From: [Humphrey, Melanie \(DEQ\)](#)
To: [David Anderson](#)
Subject: RE: Aquila Resources - MPAA - Response to questions
Date: Wednesday, March 6, 2019 11:45:31 AM

RE: Response to questions (email 5/1) for Mining Permit Amendment Application
Aquila Resources Inc. – Back Forty Project

BACK FORTY PROJECT

FIGURE 1-2
PROJECT AREA DEVELOPMENT PLAN
SHOWING EASTERN CORRIDOR
MINING PERMIT AMENDMENT APPLICATION
STEPHENSON, MICHIGAN

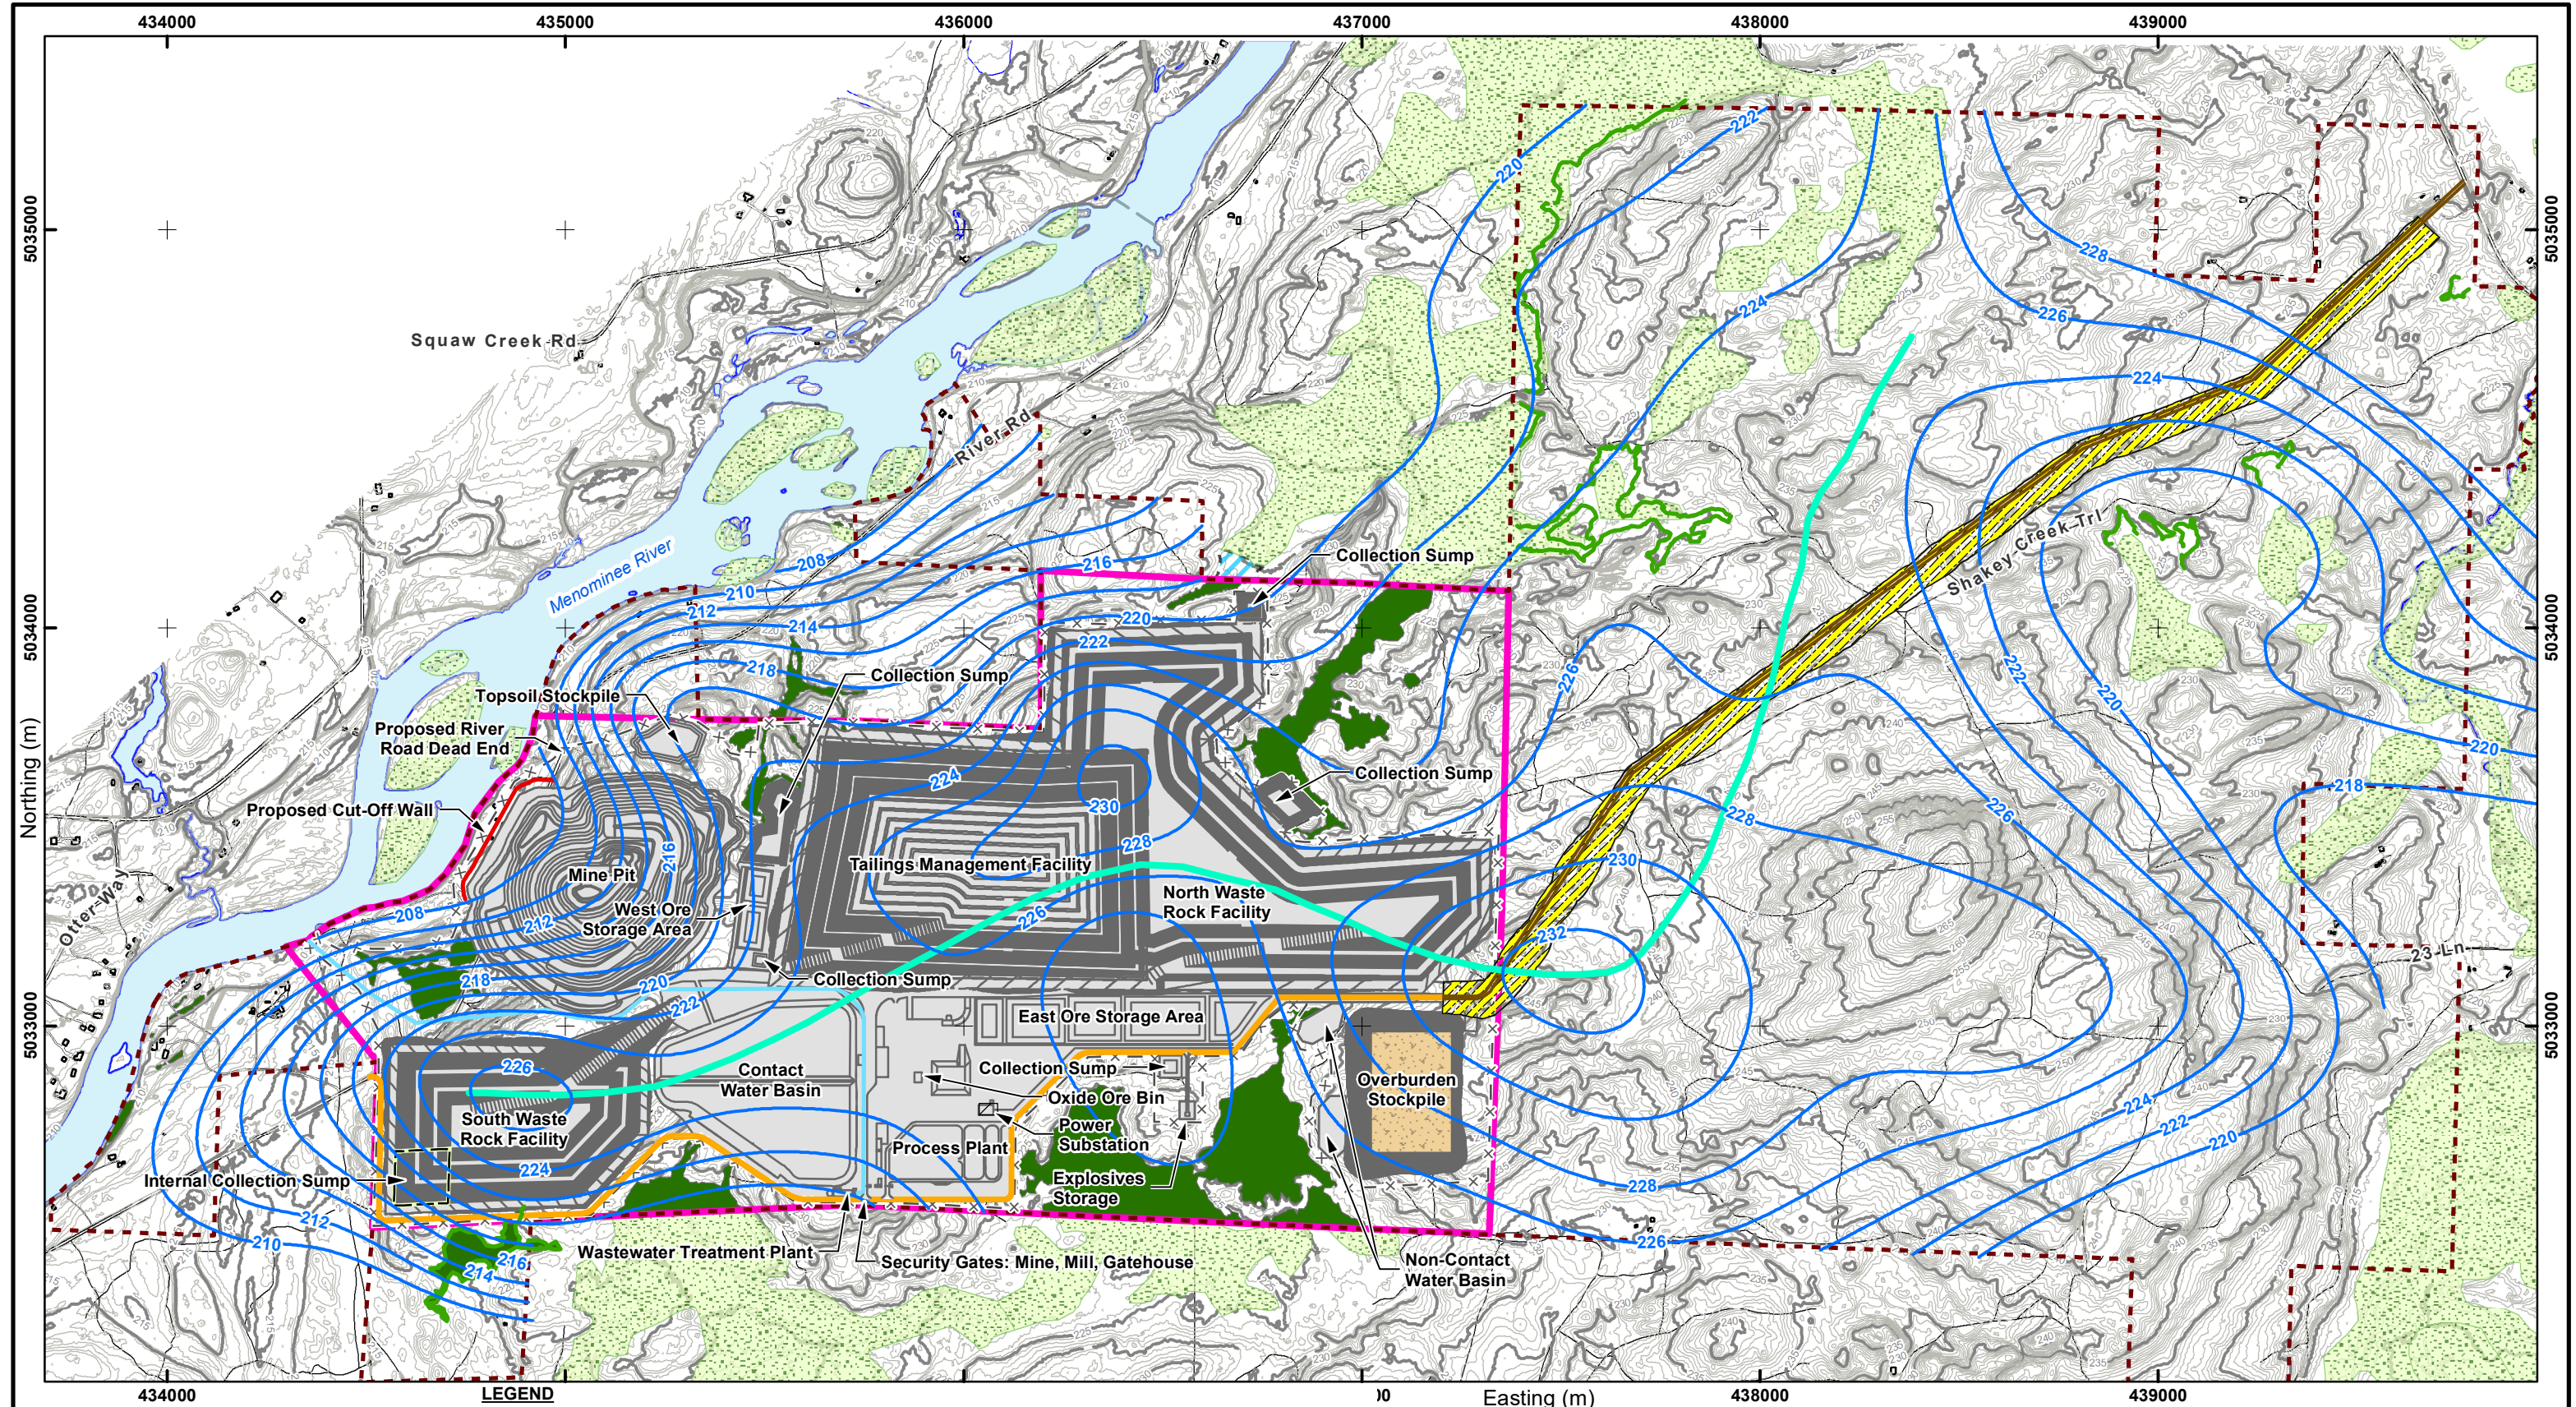
#21: Upon further consideration, please provide a Figure 1-2 with an overlay of the groundwater contours and divide.

- It would be preferable to reference an updated Figure 1-2 showing the revisions specified in following proposed permit condition (from 3/29 email):

SPC K2A: The permittee shall monitor groundwater quality and elevations at the existing and proposed monitoring well locations specified in the 3/19 revised Figure 1-2 and Table 1-1 of the MPAA/EMP, including the following additions/modifications:

- a. Reinstatement leachate/compliance monitoring well east side of the NWRF: 5033645N, 436678 E, NAD 1982, 16N
- b. Relocate CW-3 north and in proximity to LLCs-1

#21: A revised MPAA Figure 1-2 is attached with the groundwater contours and divide included.

Question # 1 - Update Fig. 1-2

Attached

Foth Infrastructure & Environment, LLC			
REVISED	DATE	BY	DESCRIPTION
	MAR. '19	AKM	Added Groundwater Contours
	MAR. '19	AKM	Added Groundwater Divide
PREPARED BY: AKM		DATE: OCT. '18	
REVIEWED BY: MJV2		DATE: OCT. '18	
APPROVED BY: SVD1		DATE: OCT. '18
